Re: Permit No. M-1980-244; Cripple Creek & Victor Gold Mining Company; Cresson Project;
VLF2 Phase 3 Stage B Revised Grading Plan

To: Evan Fonger, Manager
From: Jay Janney-Moore, P.E., Project Manager II
Reviewed By: Keith Williams P.E., Principal II
Project: VLF2 Phase 3
Project No: 475.0106.060
Subject: Draft Revised Stage 3B Grading Plan – Final
Date: 16 November 2023

VLF 2 Phase 3 Stage B Revised Grading Plan

FIGURE 4 – REVISED STAGE B GRADING PLAN

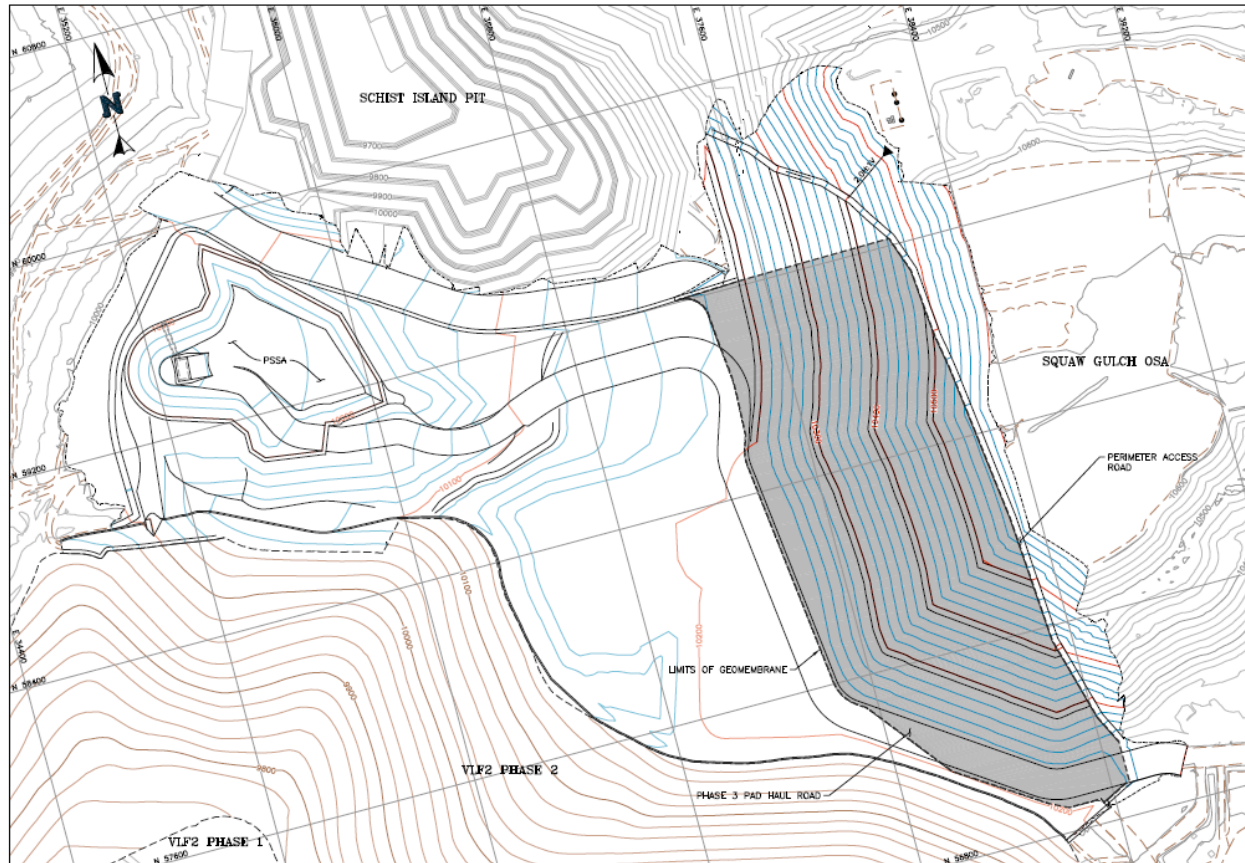
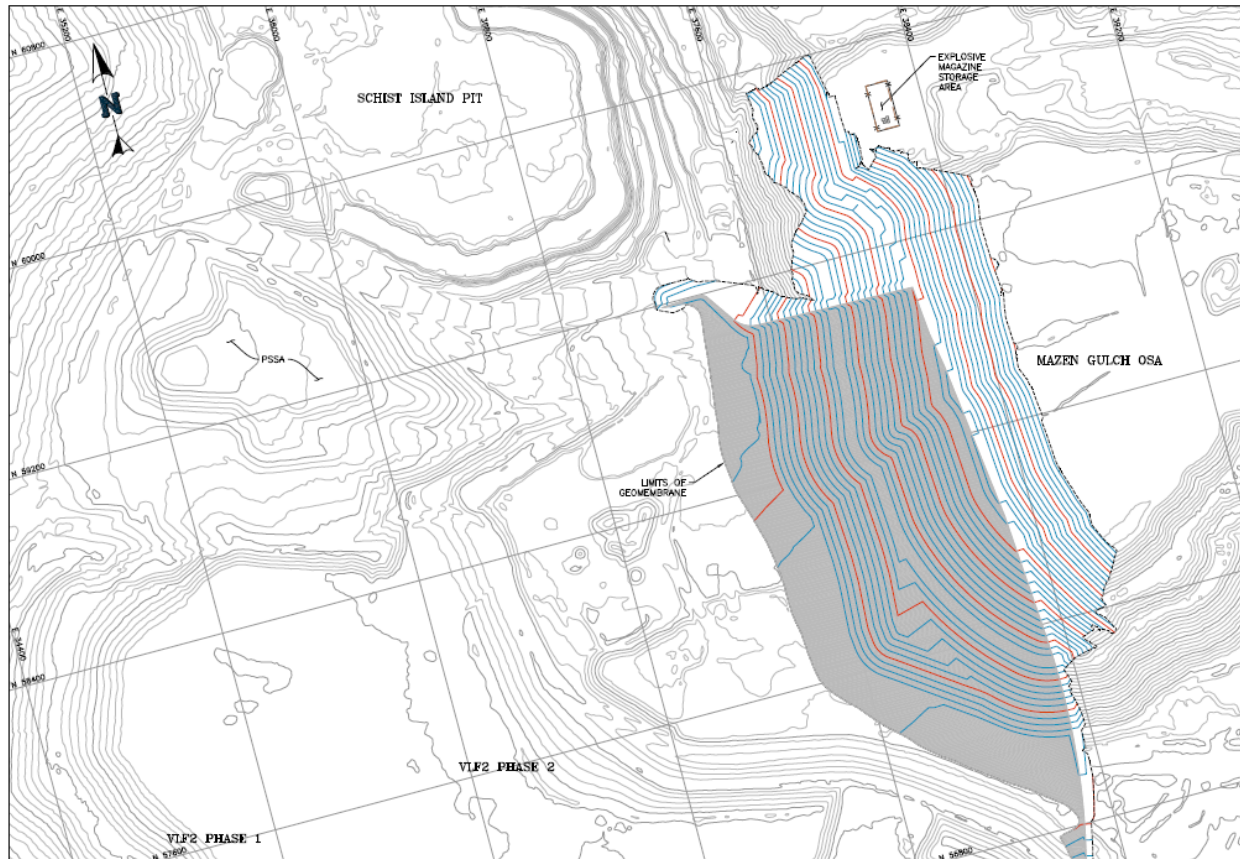
After several iterations, NewFields has developed a revised proposed grading plan, shown in **Figure 4**. Additionally, **Figure 6**, shows the revised grading plan tying into Stage C in the future. As agreed on, the revised grading plan includes the following design changes:

2.1 Pad slope of 2.5(H):1(V) between Benches

Although, a 2(H):1(V) slope is constructable, CC&V request the slope between the benches be flattened. NewFields and CC&V evaluated the earthwork volume for a 2(H):1, 2.5(H):1 and 3(H):1(V). Based upon the effort required to move the overburden material, the 2.5:1 slope was selected because it provided the best balance of minimizing earthworks while improving the constructability of the expansion. The shallower slopes are also safer for operating construction equipment on and having people on the slopes during construction. A typical section of the proposed slopes is shown in Figure 5.

2.2 Bench Spacing and Width Adjustments

The average roll length of 80-mil double sided textured LLDPE is approximately 410 feet. In the interest of minimizing geomembrane waste, the spacing of the internal construction benches was increased from 100 vertical feet to 125 vertical feet. With the proposed bench spacing and slope in the revised grading plan, the length of the installed geomembrane panel between construction benches is now approximately 375 feet, reducing the amount of waste per roll. Additionally, the revised bench spacing, and shallower slope, eliminated one construction bench from the grading plan resulting in reducing the cut volume from Dump 1.

Another request from CC&V which was incorporated into the design, the perimeter bench was widened from 25 feet to 30 feet.

2.3 Explosive Storage Area

Upon review of the existing building and infrastructure on top of Dump 1, it was determined that the existing Explosive Magazine Storage Area was located within the proposed slope reshaping. Limits of the slope excavation were revised to maintain the daylight limits a minimum of 50' from storage perimeter fence.

FIGURE 3 – JUNE 14, 2023 EXISTING TOPOGRAPHY

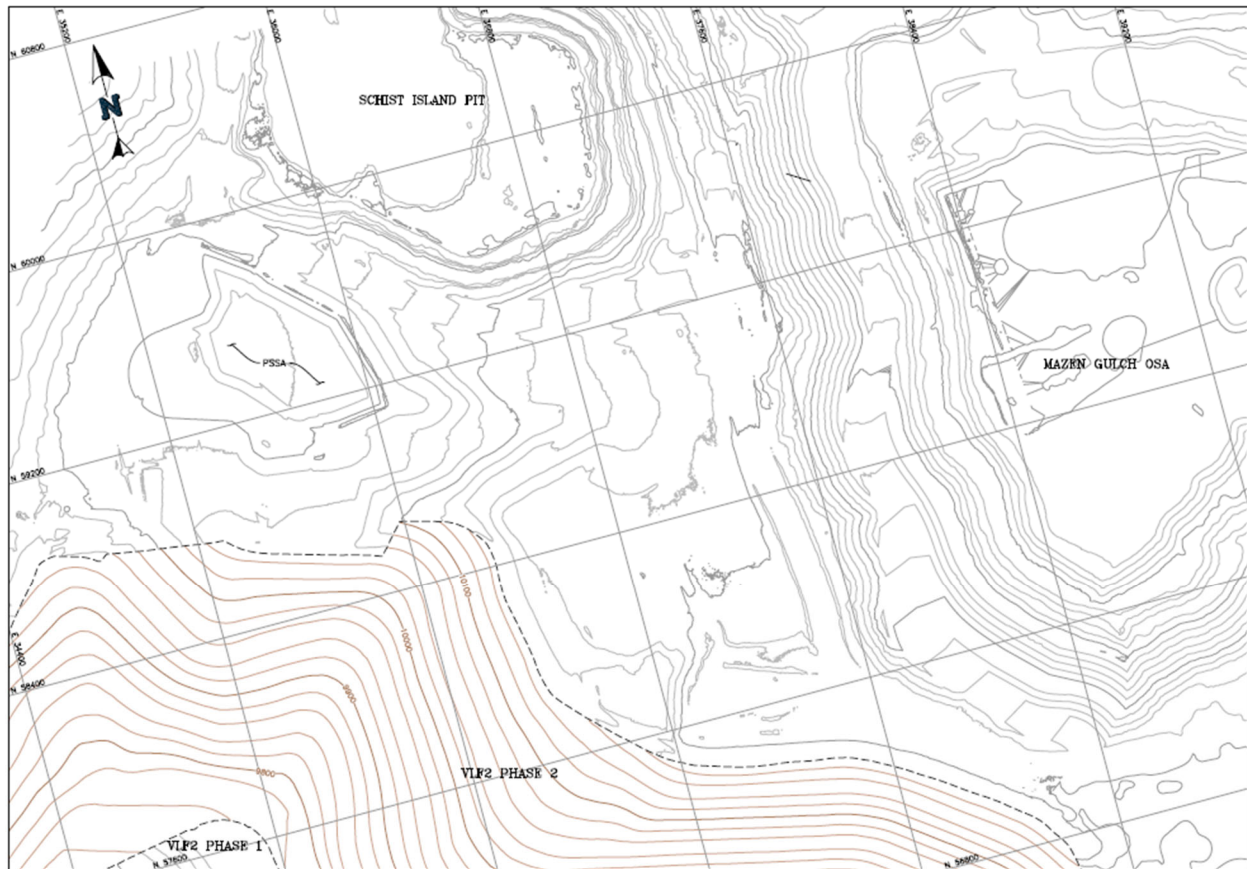
CC&V provided NewFields with an updated topography file of Dump 1 on June 14, 2023, in a file called "Dump 1 Mined out Top 06142023 ft.dxf" and requested the Stage B grading be optimized to minimize the required fill needing to be placed and compacted. CC&V and NewFields agreed to not change the limits and footprint of the geomembrane lined area for Stage B as this may be considered a major deviation from the permit and would require review and approval from DRMS. **Figure 3** shows the updated contours of Dump 1 after CC&V had constructed a haul road to the top of the dump.
